Date: January 13, 2026 Case Number: ZC-25-181 Council District: 11

Zoning Map Amendment

Site Location: 3419 E. Berry Street

Proposed Use: Mobile Vendor Food Court

SITE PLAN

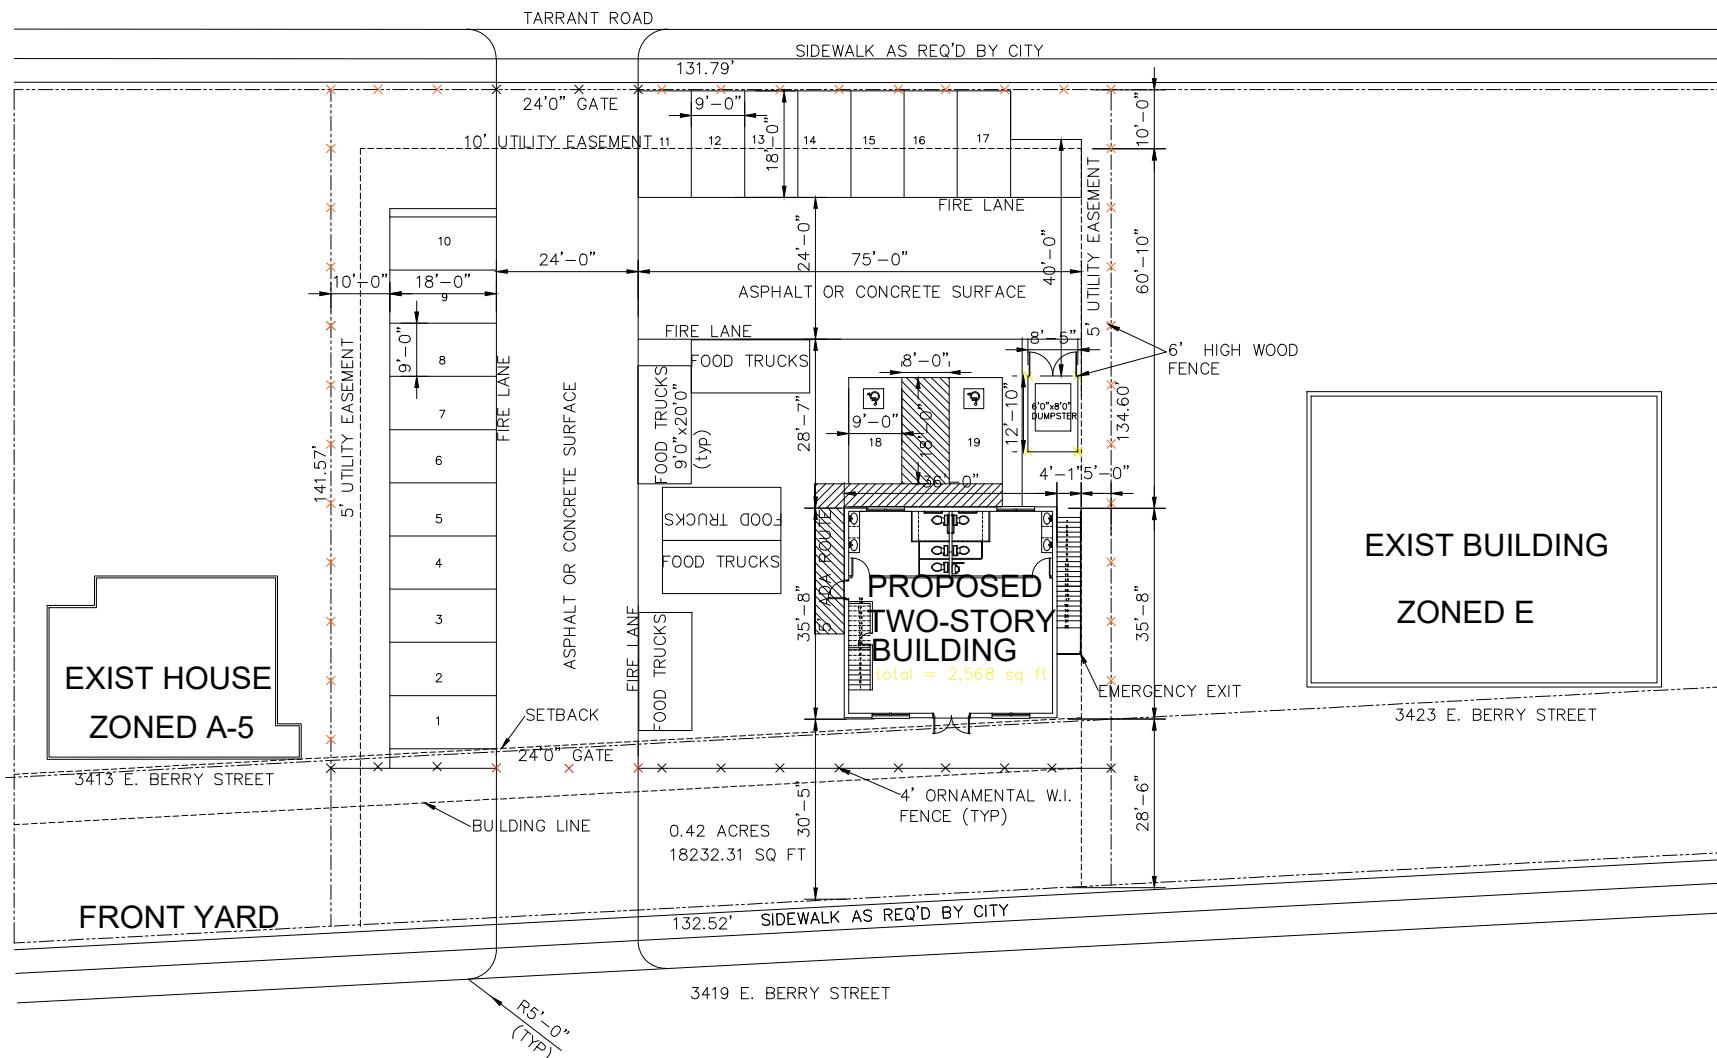
1. Correct the vicinity map, as Little Street does not go thru this block.
2. Create a surface materials legend and add these colors/patterns to the main site plan. Include the surface materials of all ground level areas, including the food truck pads, parking, and open spaces.

3. Please label the front yard of the adjacent house to the west at the project's western property line.
4. Fences are not allowed in front of commercial uses. Either remove the fence from the front yard or request a development waiver. Include information regarding the gate's materials. If approved, add the note in bold: **"A development waiver was granted to allow a 4-foot open-design fence and gate in the front yard."**

5. Because the lot has a street on both the front and rear, it is considered to be a through lot. Through lots that adjoin a residential street have a 20-foot yard on the rear yard. The rear fence is in the required 20-foot rear yard setback. If approved, add the note in bold: **"A development waiver was granted to allow the rear fence in the required 20-foot rear yard for a through lot."**

6. Show and label the water/sewer connections to the food trucks, instead of the electrical connections. This information can be shown on a separate page if the main site plan is too busy.

7. If lighting is provided, show and label it. Add the footcandle level at the property line. This information is required now, instead of at the building permit stage.

8. Show and label the proposed detached sign. Note if the sign will be illuminated or unilluminated.
9. Label the land use and zoning classifications of the surrounding properties in all directions, as well as the subject site.

10. Show the parking calculations based on the seating area size.
11. Informational comment: Signage is not allowed on fencing or gates.
12. Generally, the site plan is hard to read, as the lettering is very faint/almost ghosted. Is there a way to print the PDF where the plan information shows better?
